RESPONSE
TO THE
DESIGN REVIEW PANEL REPORT
DATED FEBRUARY 2010
FOR THE
PROPOSED
COMMERCIAL DEVELOPMENT
KNOWN AS SY3
AT
NO 639 GARDENERS ROAD MASCOT

This Response has been prepared by James Nangle of Planning Strategies Pty Ltd

February 2nd 2010

PARAPET REDUCTION

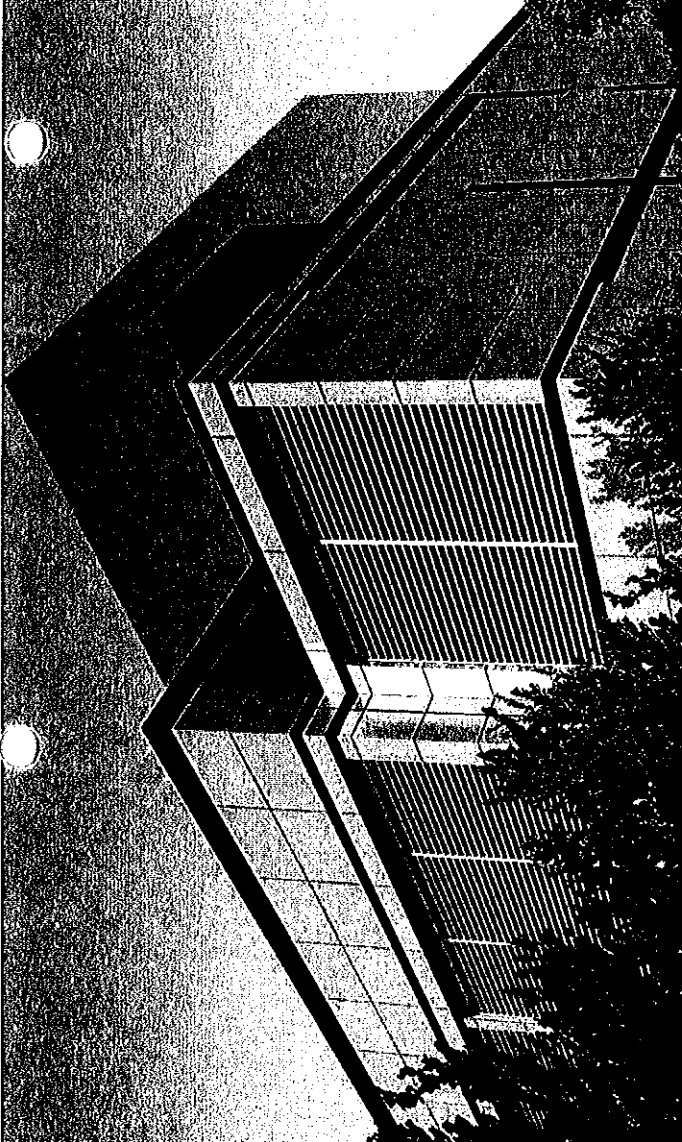
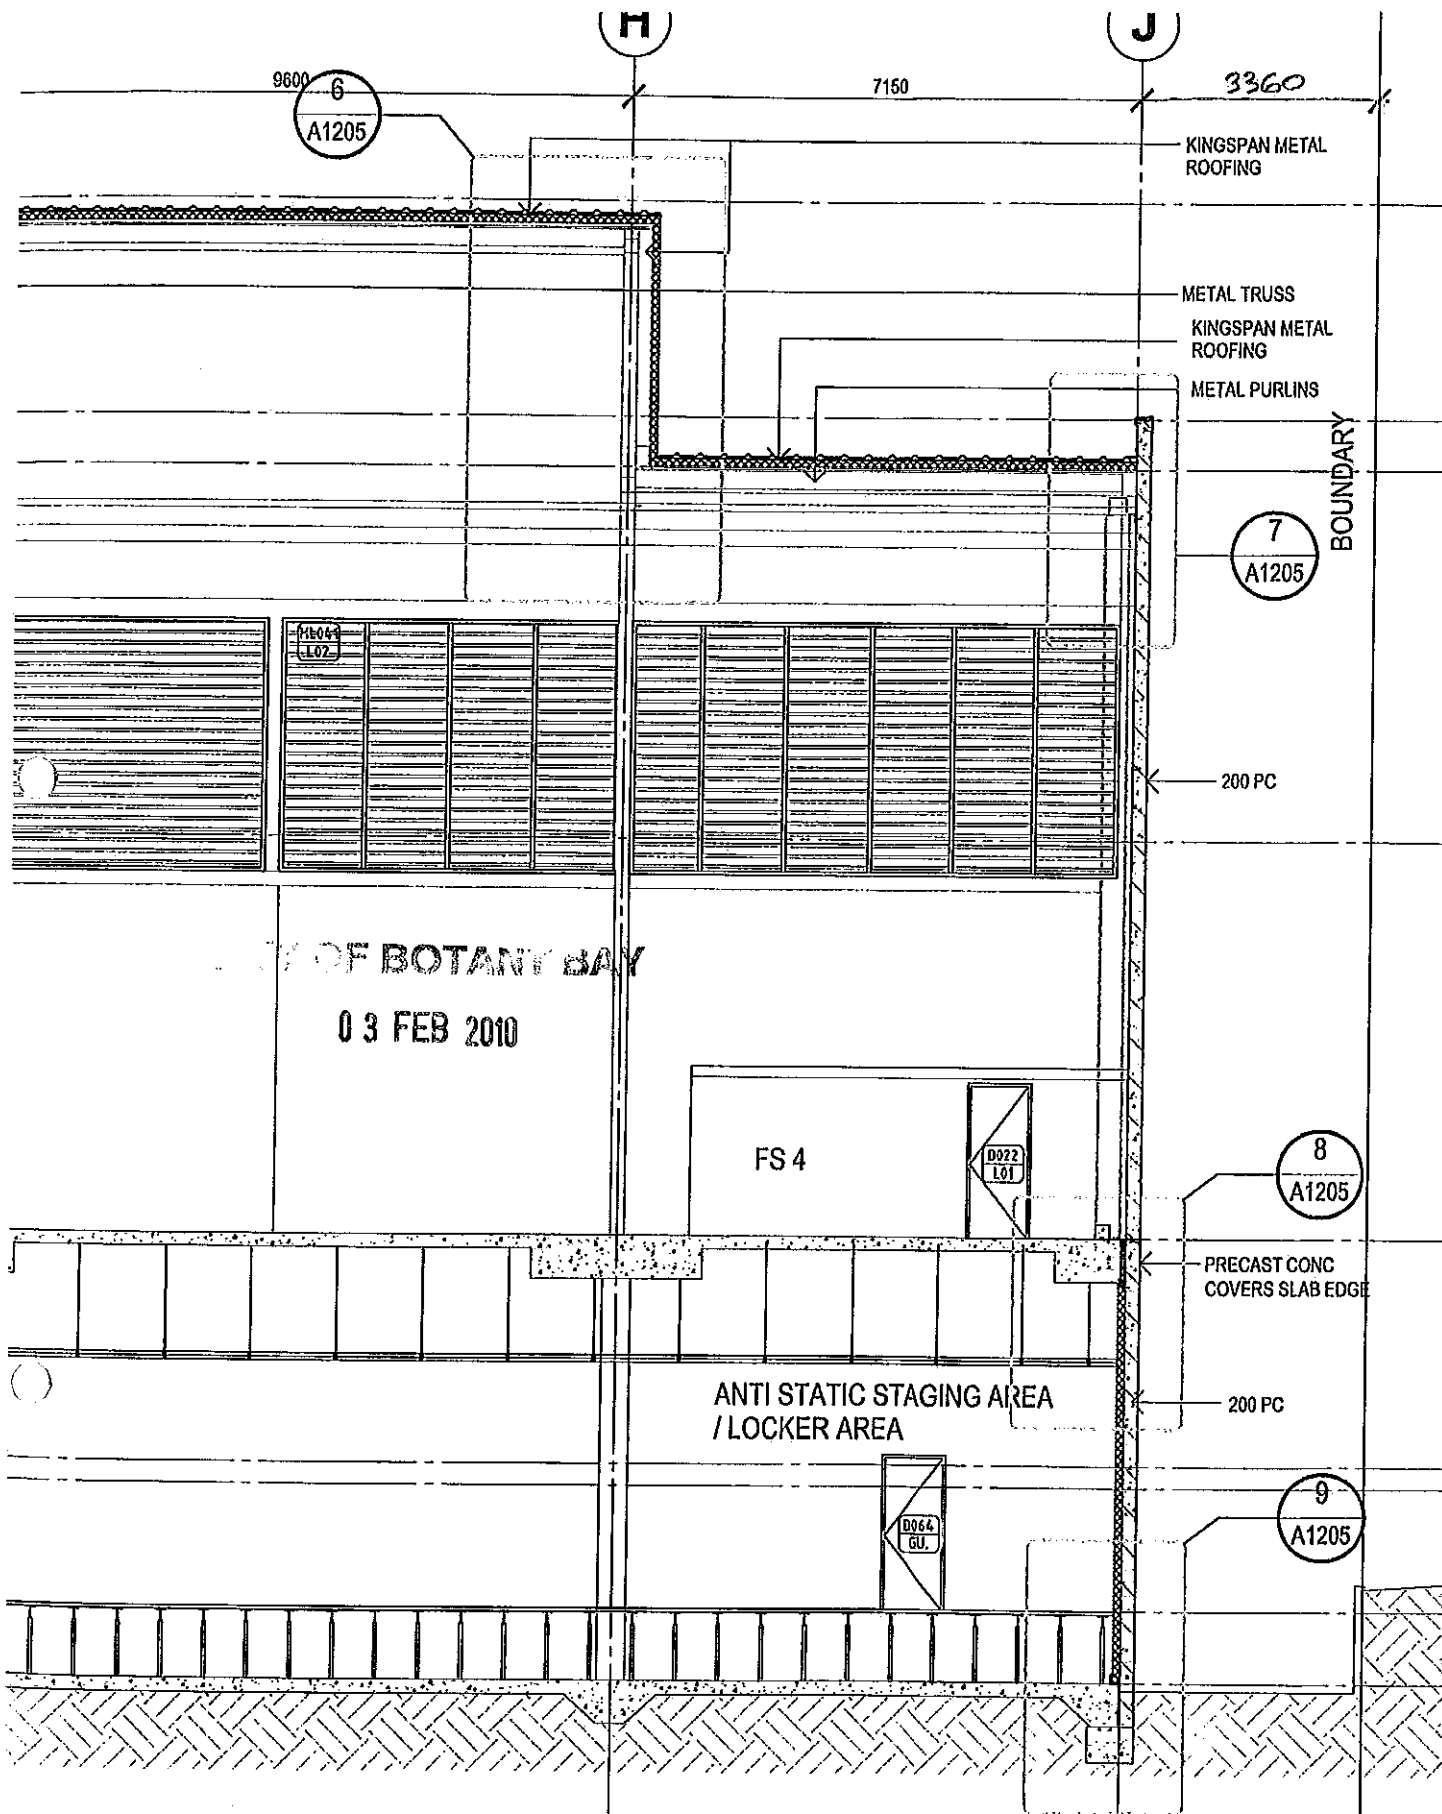
Item: 'Satisfactory Except for south-east corner'

Resolution: The scale of the proposed development in the south east corner has been reduced as requested. The 3.0 metre high perimeter parapet wall to the south east corner has been moved back as far as possible to reduce the bulk and scale without compromising the acoustic requirements of the building. The acoustic treatments to the proposed building remain the highest standard. There has been no compromise in the noise attenuation measures as a result of the design change.

The setback of the parapet will reduce the visual bulk as requested and improves the amenity of the adjoining residential units. It is proposed to finish this baffle wall so that it blends more with other background structures (see revised detailed Architectural drawings)

Resolution : a) As advised above in Scale the overall height of the screen wall along the south east corner of the proposed development is reduced at the boundary by 3.0 metres by setting back as far as possible. for –

- A length of 6.8 metres in a westerly direction and for
- A length of 14.5 metres in a northerly direction

Access to the roof is now via access hatch and ladder.

EQUINIX 8Y3
SECTION NTH OF
GRID 4 (A)
18/1/10 LTS FOR DDA.
SCALE 1:100

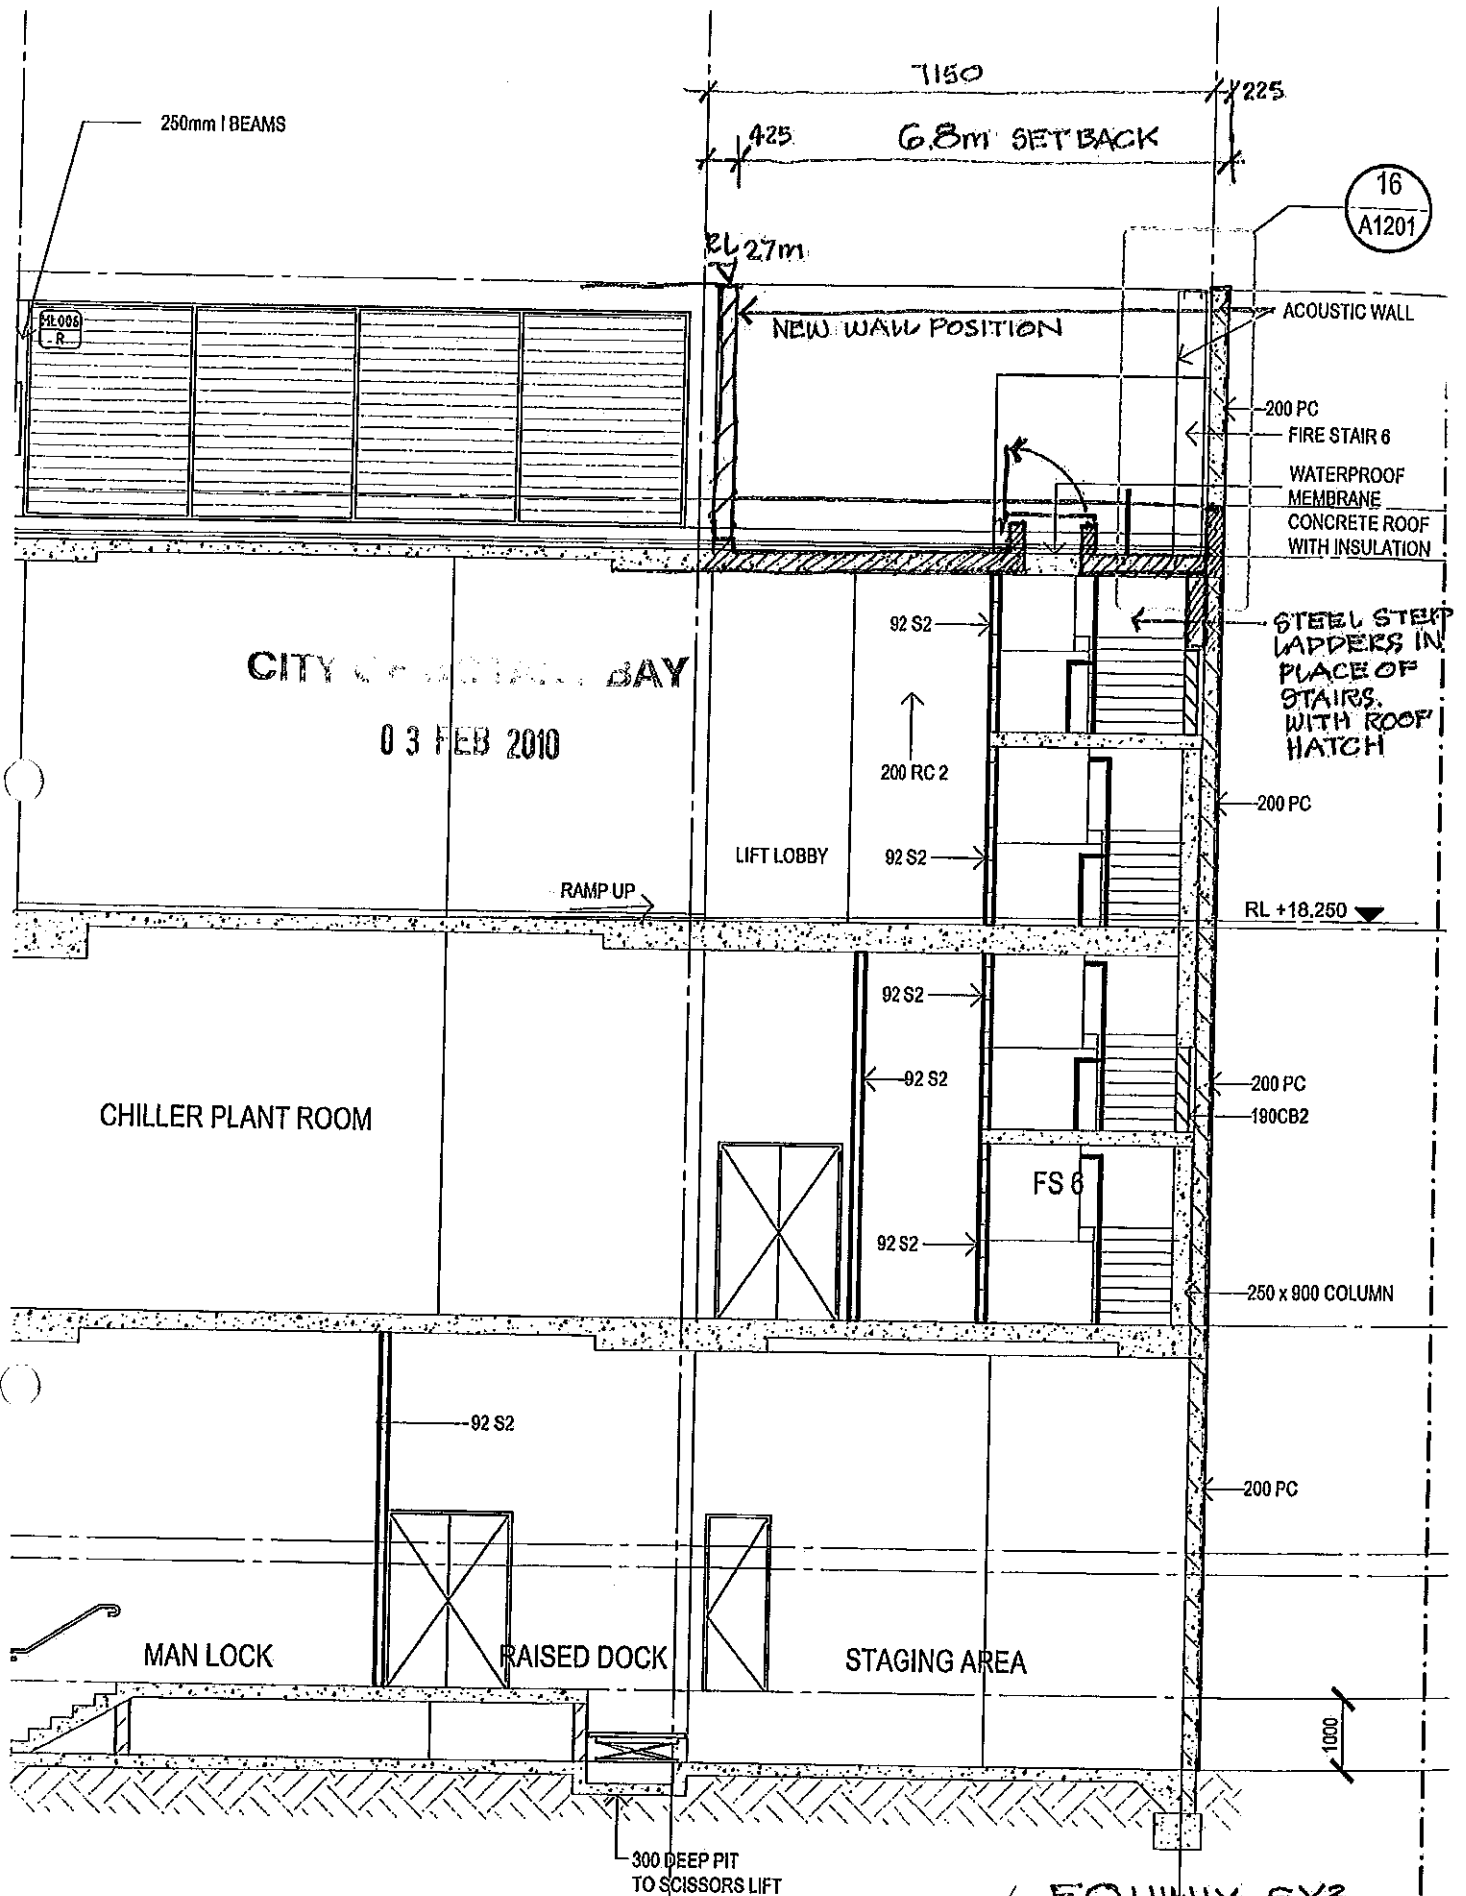
Item: South east corner visual bulk and neighbour amenity
